**CORRO-CONSULTA**

**Memorandum**

**Subject: Review of Fitness for Service Assessment of Oyster Creek Dry Well on the Basis of Extended Data Analysis**

Figure 1

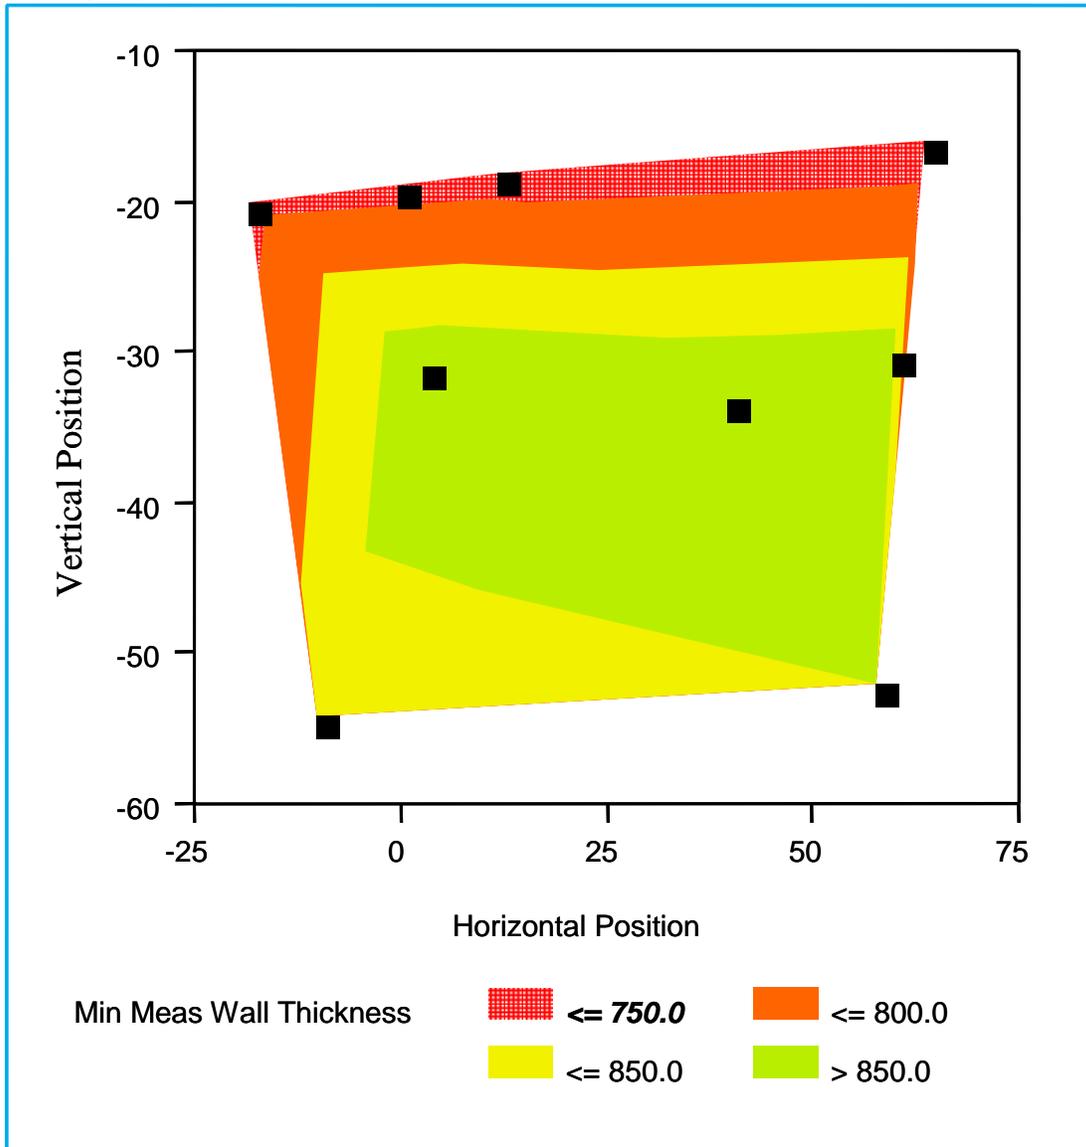
possible. However, we can look at the situation and gain intuitive insight into this question. Figure 1, which is discussed in detail below, presents areas of equal wall thickness (contours) based on the measurements, shown as the points, performed on the outside of Bay 19 in 2006. Note the dark squares are 2.5 inch on each side (and drawn to scale with reference to the horizontal axis), hence cover the area of measurement claimed by AmerGen. It turns out that the measurements at the -20 (inch) vertical position are on average less than 0.725 inches. Since measurements had not been extended to higher elevations one has no assurance that there are no more seriously corroded areas either between those measured or further up in the sandbed.

The advantage of this evaluation is that one can see all the available data in a quantitative presentation. Thus, one can see in Figure 1 that an area exists at elevation -20 (20 inches below the reference point) where the remaining wall thickness is less than 750 mils, or less than the criteria for general thinning at 95% confidence. This area extends from 20 inches on the left (-20 inches) to about 60 inches on the right (+60 inches), or about 7 feet. The width of this area in Fig. 1 is maybe 4 to 5 inches, however, because measurements were not extended toward lesser elevations (from the reference point) one simply cannot estimate how much further the serious the corrosion may extend in Bay 19.

**Figure 1** mentioned previously shows a heavily corroded area in Bay 19 at elevation -20. The extent of this area is highly uncertain because it was not further defined by additional UT measurements toward higher elevations (>-20). Indeed, one could find here an extended bathtub ring area.

Figure 2  
Bay 1 Remaining Wall thickness  
External UT Measurements 1992/1993

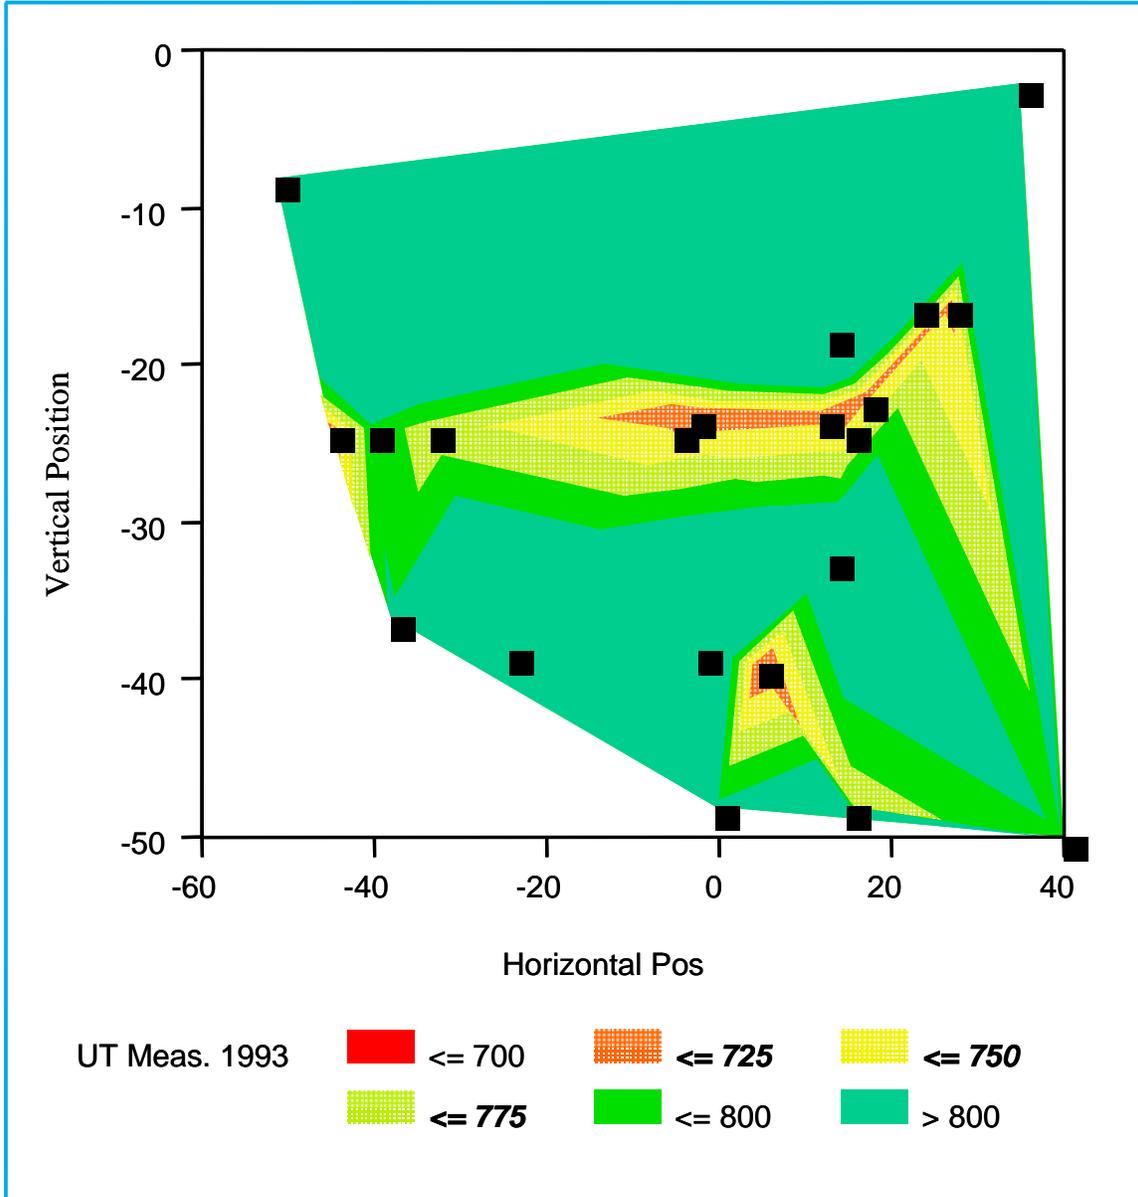
The data used for the analysis are contained in Tables 1 and 2 for Bays 1 and 13 as extracted from AmerGen documents. Presumably, these were the most corroded Bays. Figure 2 shows a contour plot for Bay 1 obtained with the data from 1992. The dimensions of the points in the plot are 2.5 by 2.5 inches. Again, one needs to remember that the specific shape of the contours depends not only on the residual wall thickness measured at the locations indicated, but on the density of measurements as well. (For instance, an additional measurement at coordinates  $h (-20) v (-25)$  could completely alter the contours and in all likelihood extend the area of wall thickness below  $-750$  mils <sup>4)</sup>.

Nevertheless, it appears in Figure 2 that in the so called “bathtub ring” an extensive area exists with wall thicknesses between 700 and 750 mils (0.75 inches). This area extends well over 52 inches (4<sup>+</sup> feet) and is about 5 inches wide. In view of the fact that UT measurements are at best accurate with a standard deviation of about 45 mils, (95% confidence limits +/-90 mils), this area could well be more extensive.

Figure 3

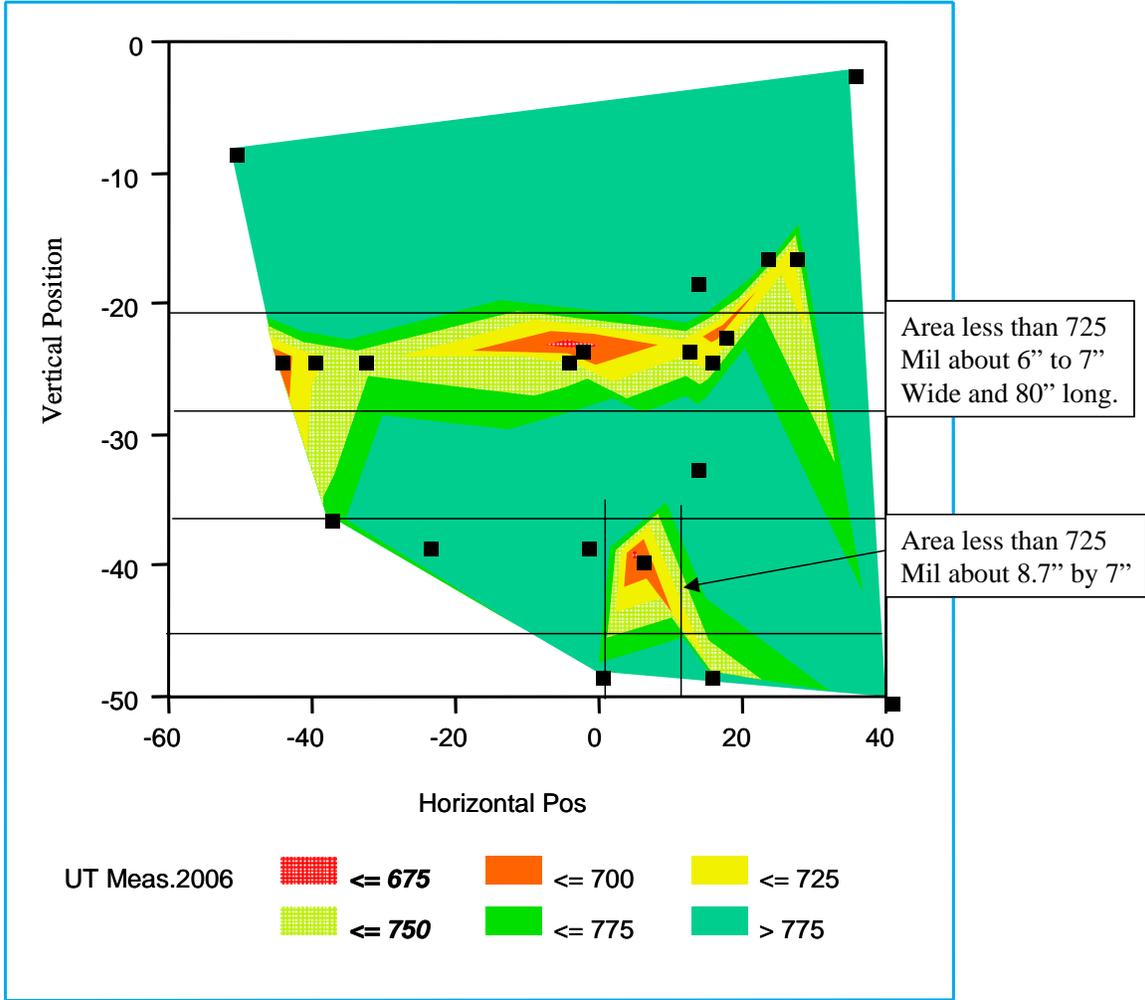
**Figure 3** shows the contours for Bay 1 obtained with the data from the 2006 inspection. The general shapes are the same as in Figure 2 except that here we have sizeable areas with residual wall thicknesses below 725 mils. The unexpected thing is

that these areas seem to extend on the left beyond h -40 inches but no measurements are available to verify whether AmerGen did in fact manage to capture all of the most corroded areas as claimed.

Based on Figure 3, together with an assessment of the accuracy (reliability) of the data one must conclude that there is a good likelihood that the entire bathtub ring area extending from 40 to -40 inches on the horizontal axis and from about -30 to perhaps -20 inches on the vertical axis is below the 0.736 inch criteria for general thinning and is, much larger than the one square foot acceptance criterion. (Of course, since this area is the most corroded, it will taper off to higher wall thickness on both sides of the vertical axis). The corroded area is indeed shaped quite irregular, but one could venture a guess that the contoured areas below 750 mils are of the order of 4 to 7 square feet all together. This estimated area does not include the area to the left of -40, which probably contains additional area below 0.750 inches.

Figure 4

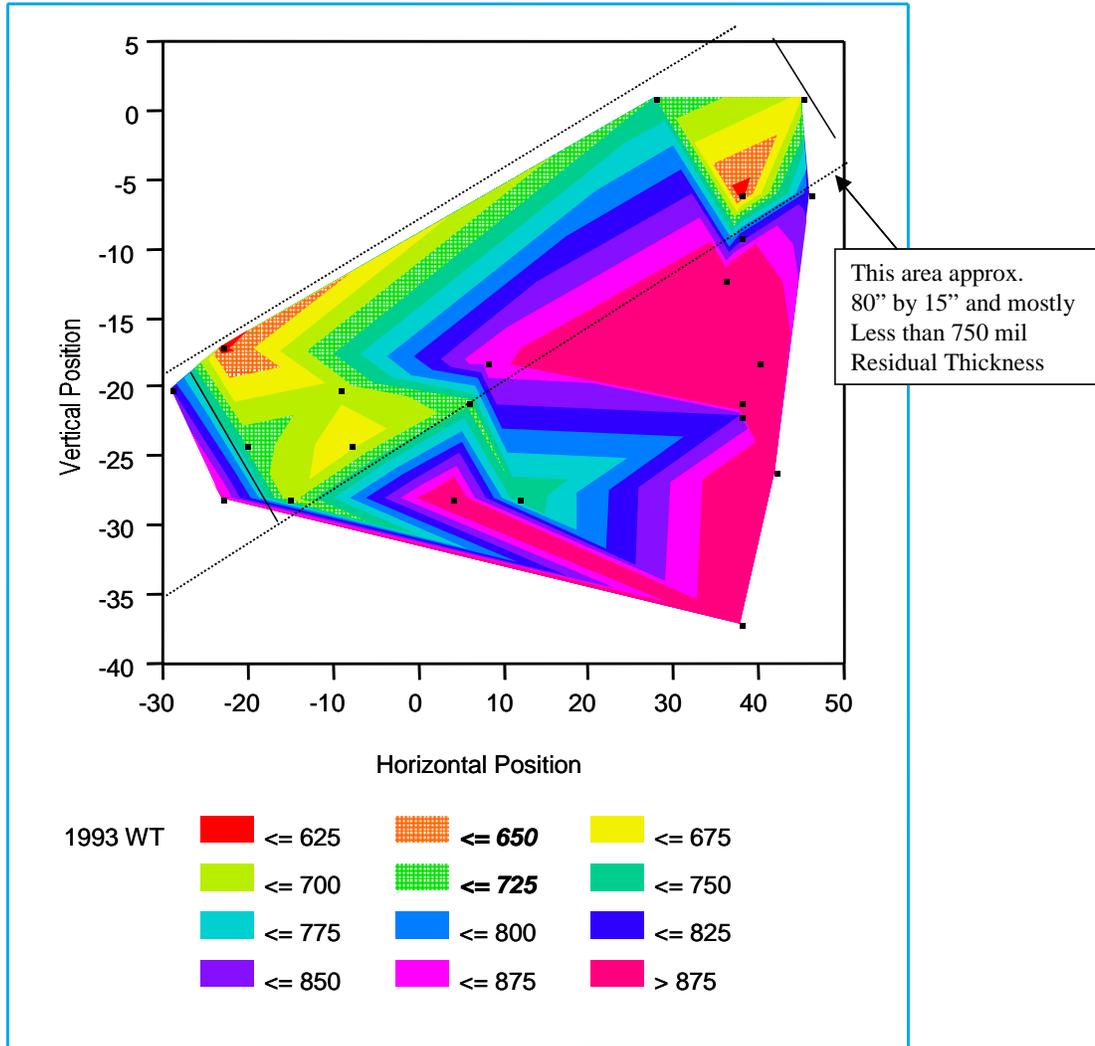
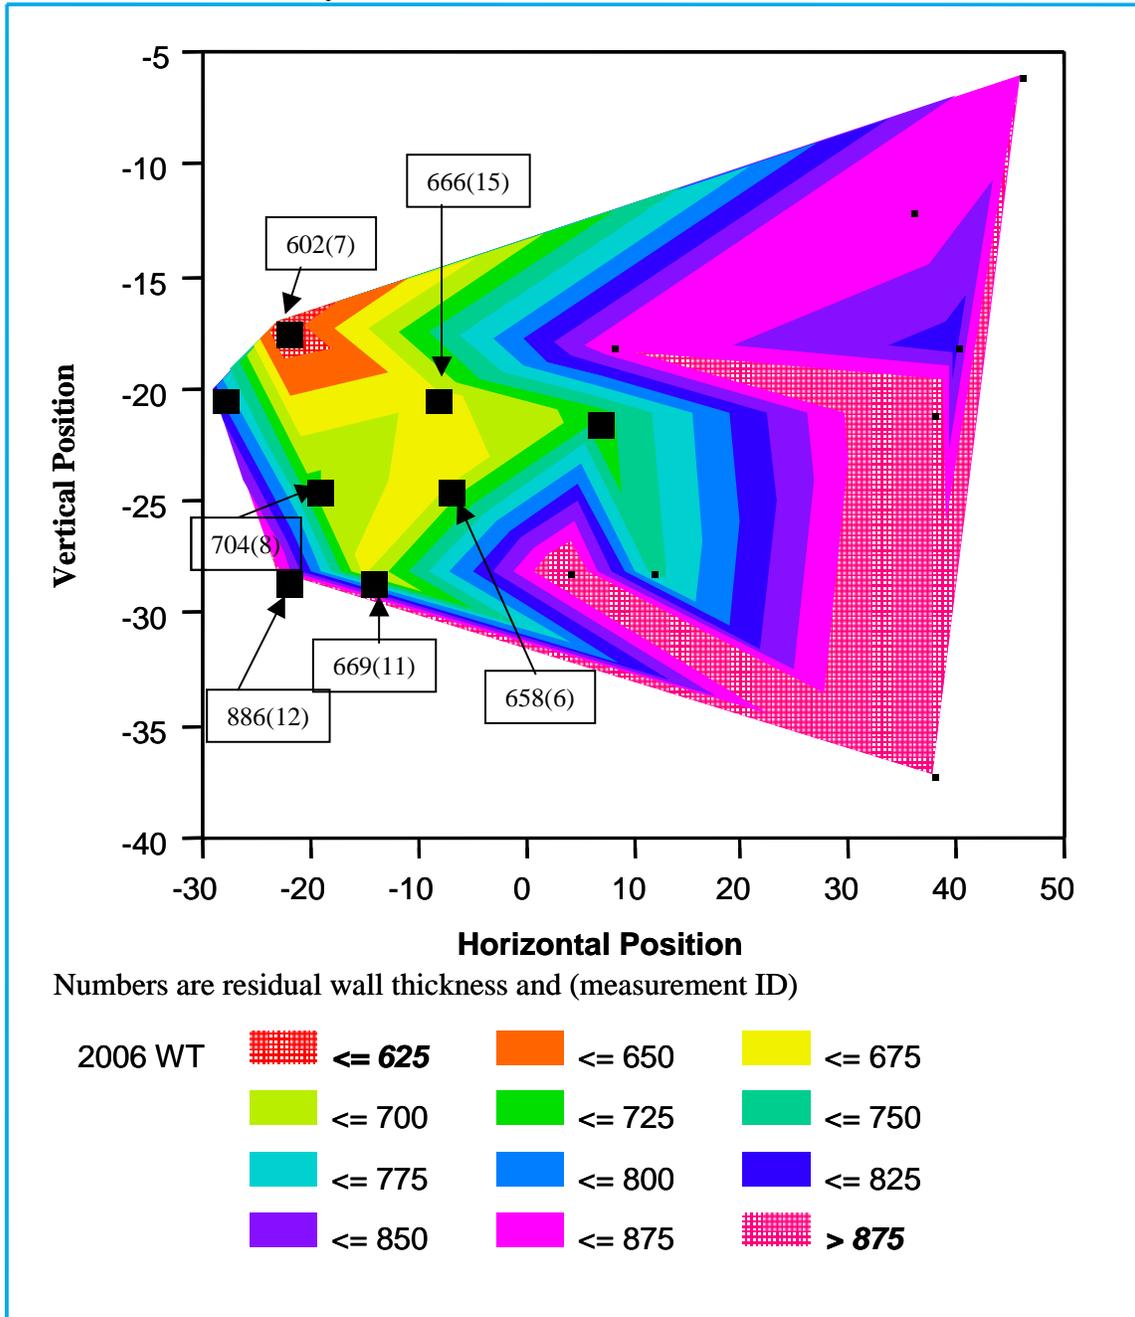
**Figures 4 and 5** show the contours for Bay 13, 1992 and 2006 data, respectively. Here large areas exist with wall thicknesses below 700 mils and at least two seemingly unconnected areas where the residual wall thickness is less than 650 mils. It could be argued that those heavily corroded areas are less than 1 square foot and therefore are still acceptable according to the 636 mil criterion. However, the heavily corroded area on the left hand side (-20, -20) has not been further explored. One therefore does not know whether it might extend further. Similarly, the area on the right ((40, -7), clearly showing a fairly deep pit, was not further explored and was not even measured in 2006. While in Bay 1 the bathtub ring was at elevation -20 to -25 (from the reference point) in Bay 13 there is no clearly prominent bathtub ring. This may be because it was not there, but it may also be because the measurements were not extended toward elevation -15 and -10. We are therefore left with a great uncertainty as to the true extension of the damage in this Bay.

- If an area is less than 0.736 inches thick then that area shall be greater than 0.693 inches thick, and shall be no larger than 6 inches by 6 inches. C-1302-187-5320-024 has previously placed an area of this magnitude in Bay 13 **(Ref.2)** <sup>5)</sup> Actually, as can be seen from Figure 4, there are two such areas in Bay 13.
- Most recently, the limiting wall thickness criterion was formulated as follows: *An evaluated area for local buckling shall not be greater than 36 inches by 36 inches wide. The center of the area shall be no larger than 12*

Figure 6

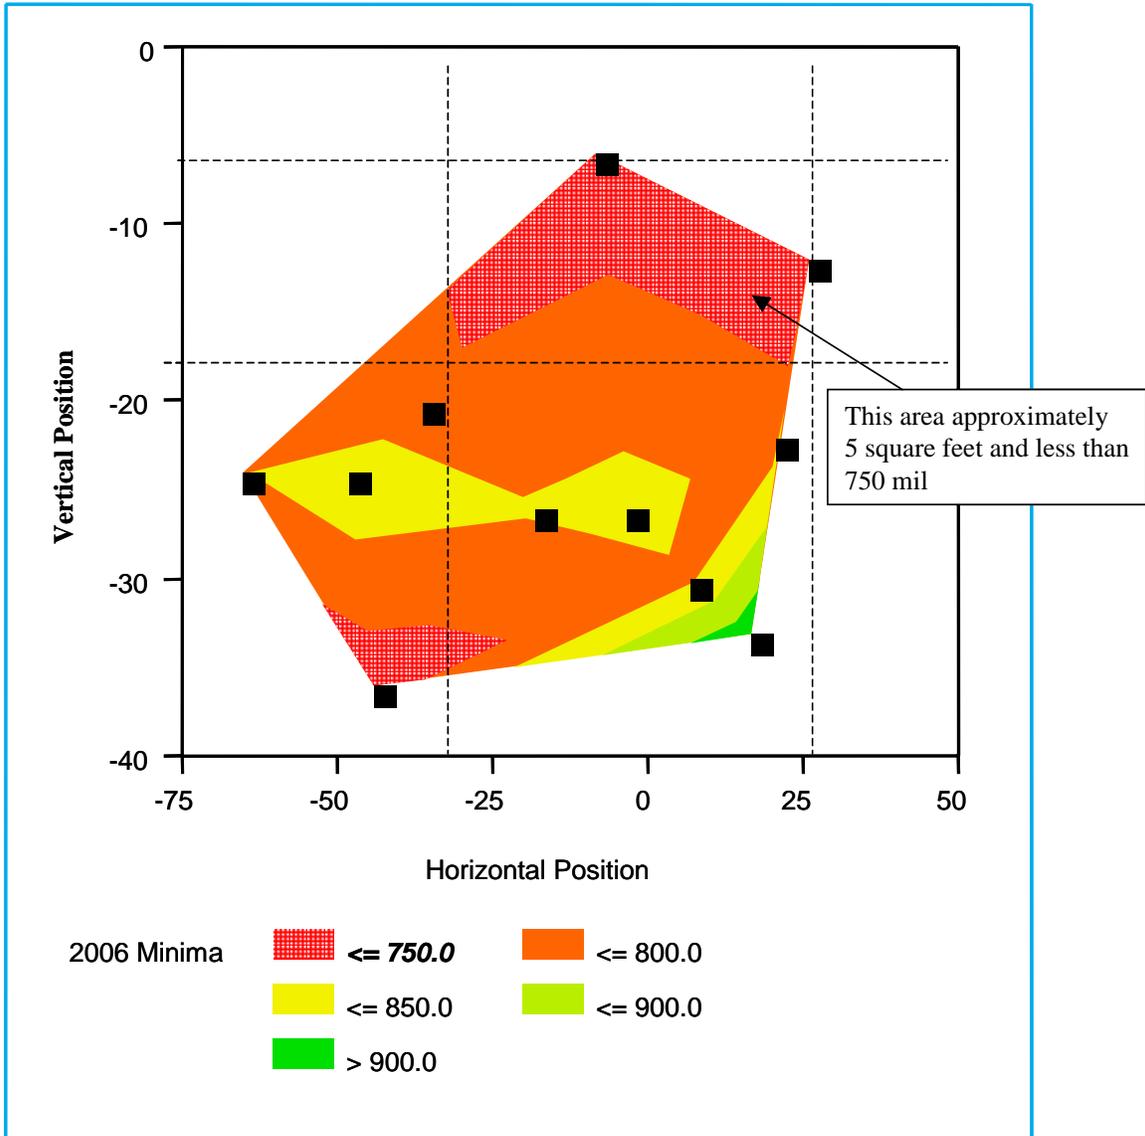
**Figure 6** shows the contours for Bay 15. There is a heavily corroded area at elevation -10 with an extension of 1 ft by about 4.5 feet. However, this area was explored only with 2 measurements and was not extended beyond about 2 feet either side of the centerline. It appears that the majority of the measurements occurred in the non-corroded zones. Interestingly there appears some serious corrosion near the sandbed bottom, but the occurrence was not further explored either.
